TENNESSEE VALLEY AUTHORITY
WATTS BAR NUCLEAR PLANT (WBN)
UNIT 1 - DOCKET NO. 390

PROPOSED TECHNICAL SPECIFICATION (TS) CHANGE TS-00-06

PROPOSED TECHNICAL SPECIFICATION (TS) CHANGE TS-00-06

MARKED PAGES

Figure 2.1.1-1 (page 1 of 1)
Reactor Core Safety Limits

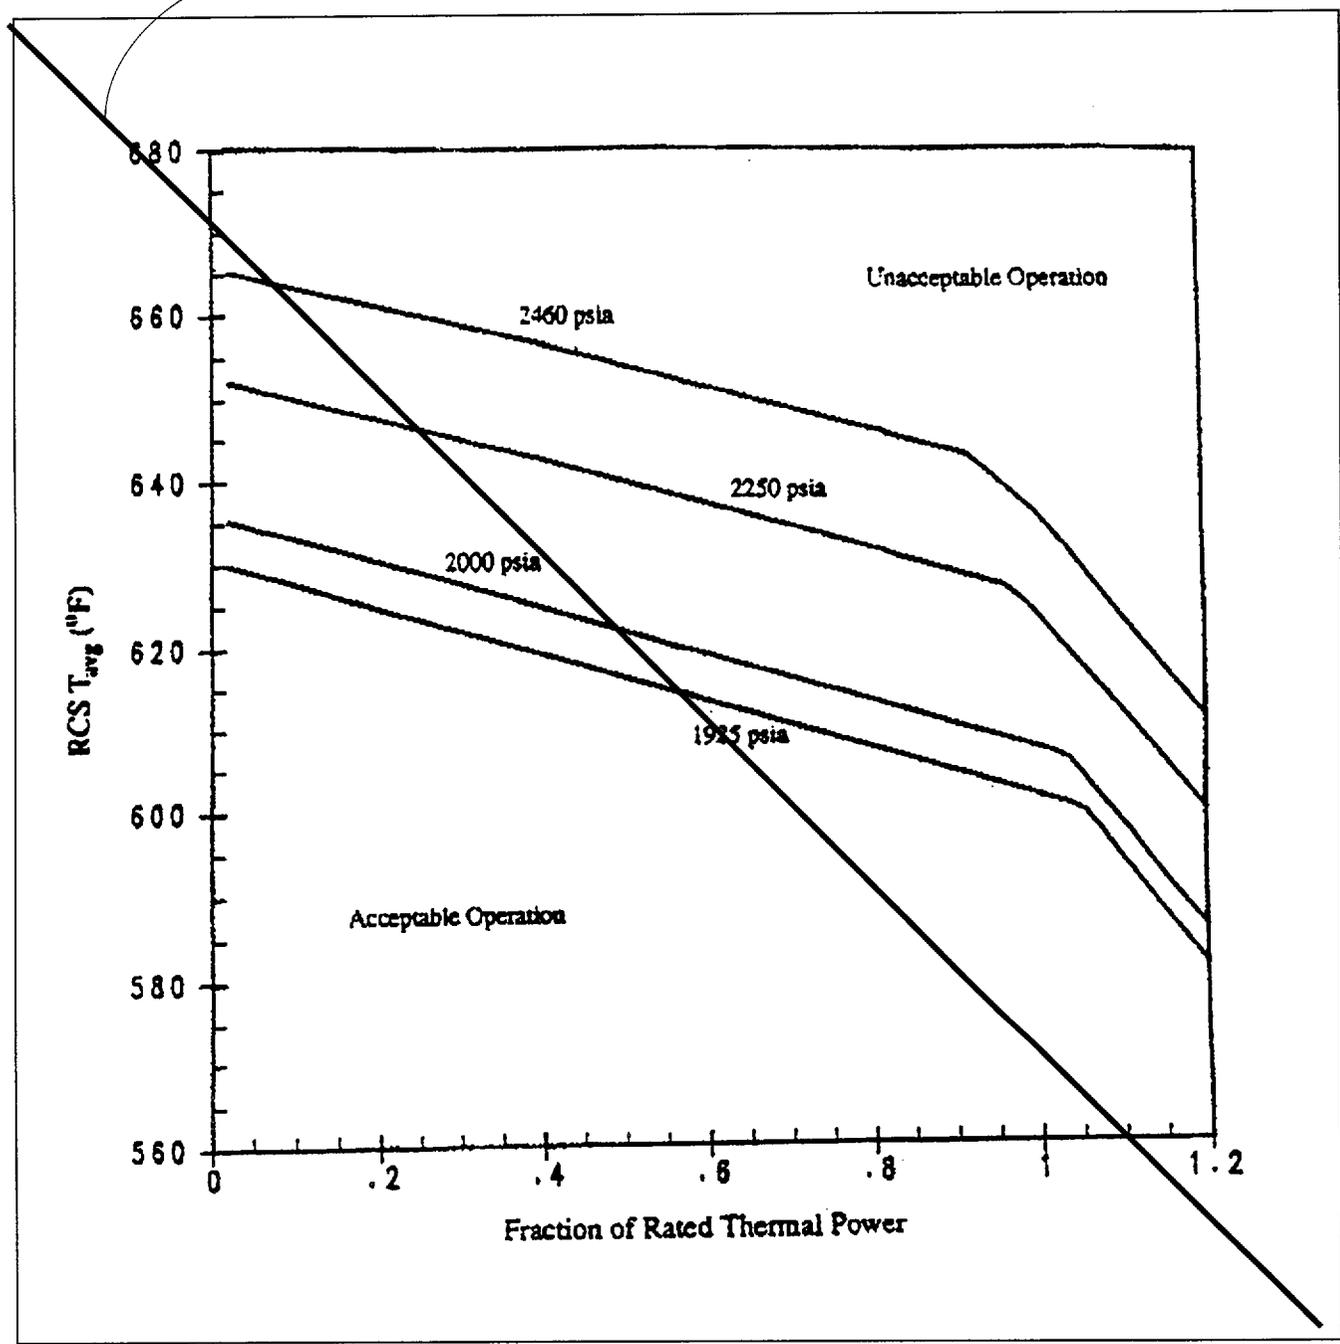
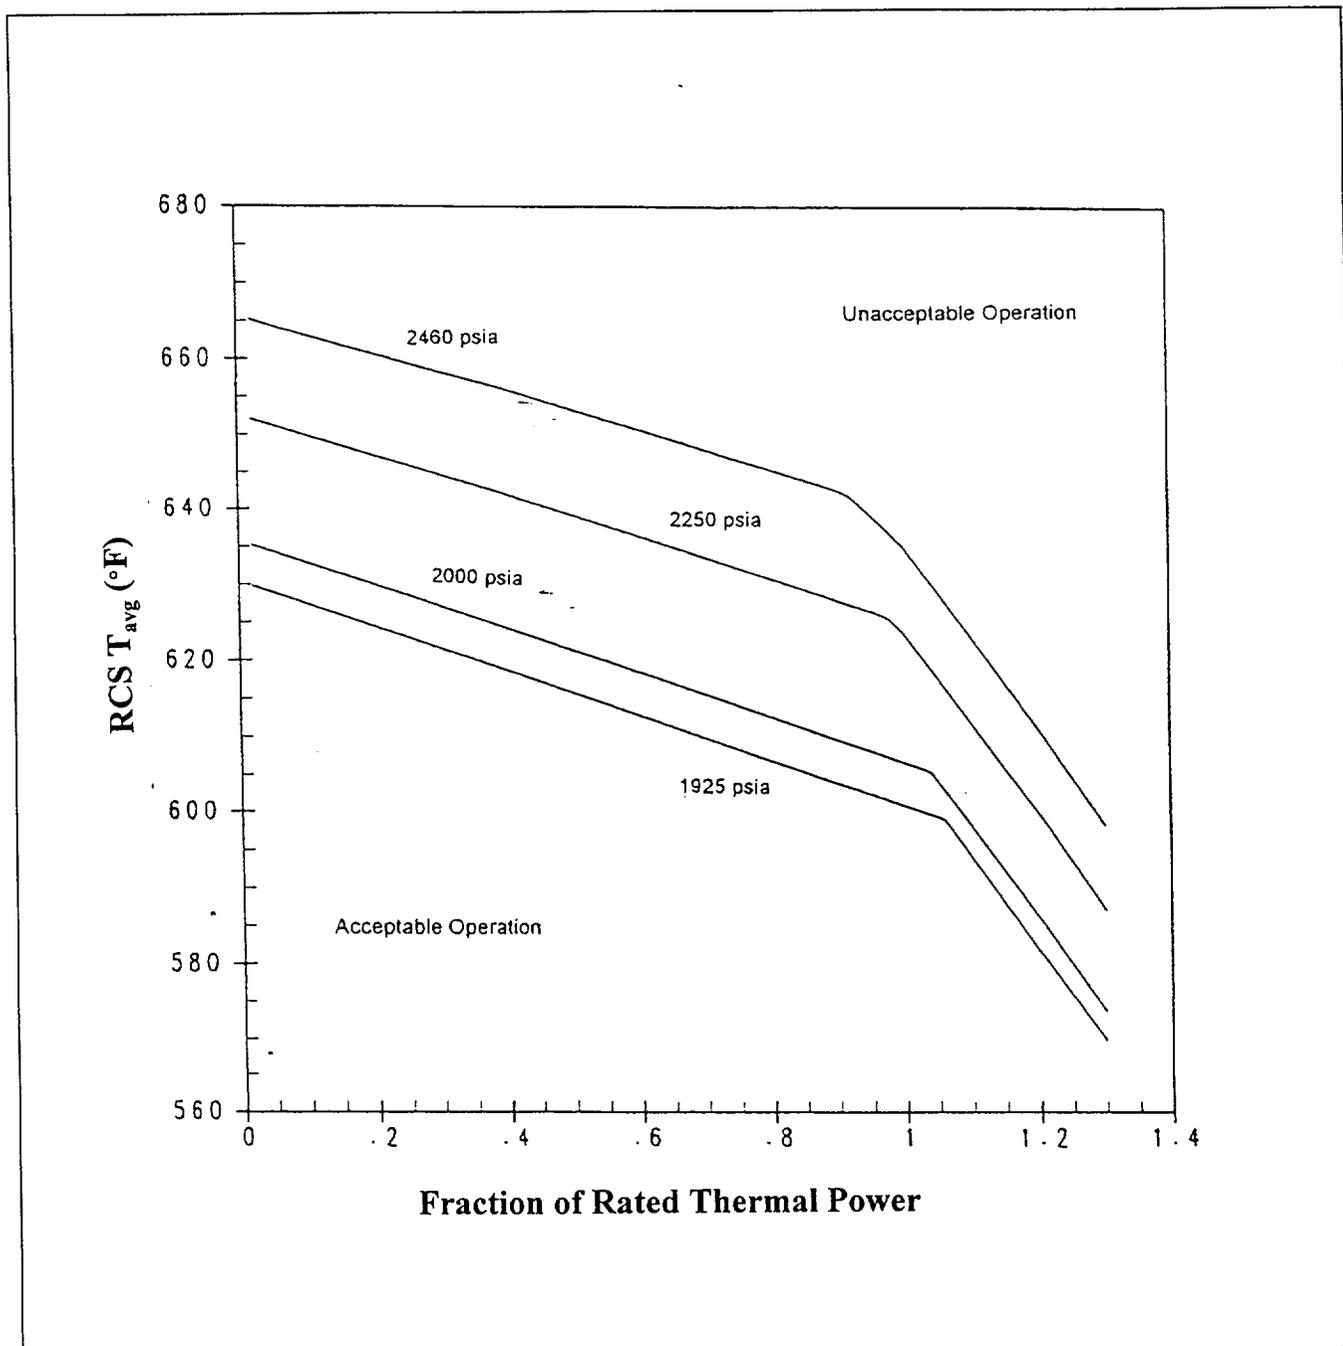
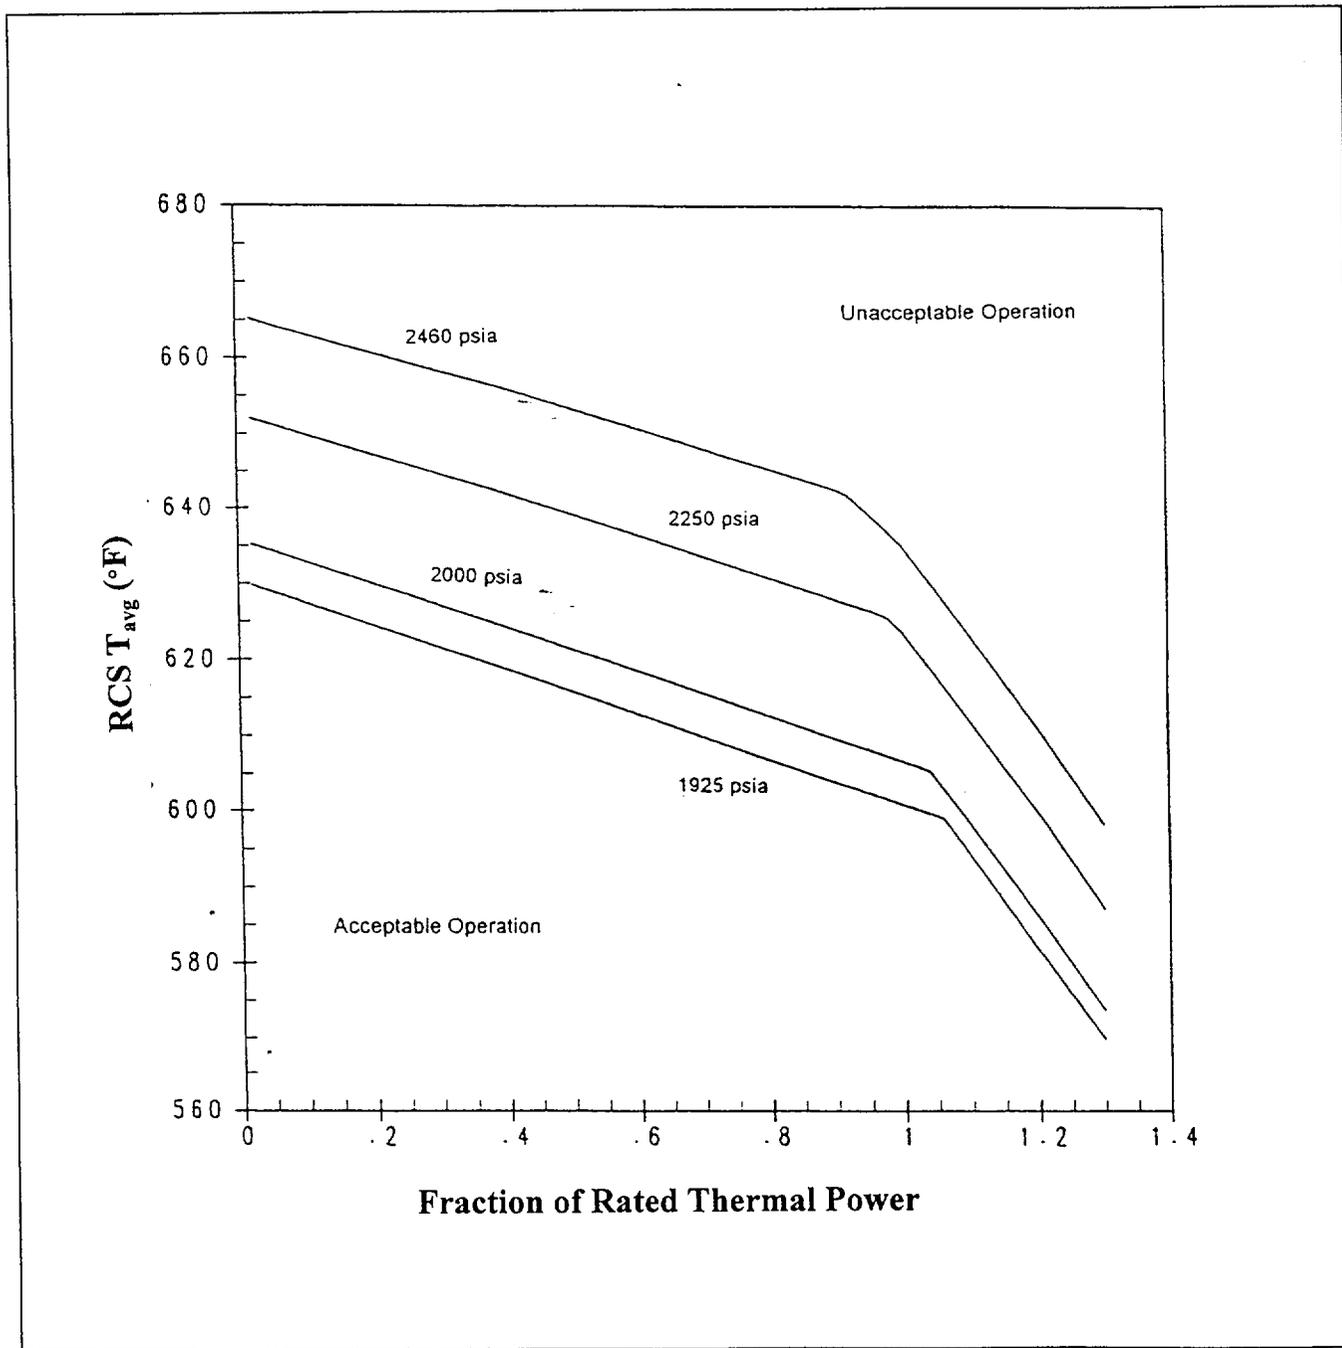
REPLACE WITH THE ATTACHED FIGURE
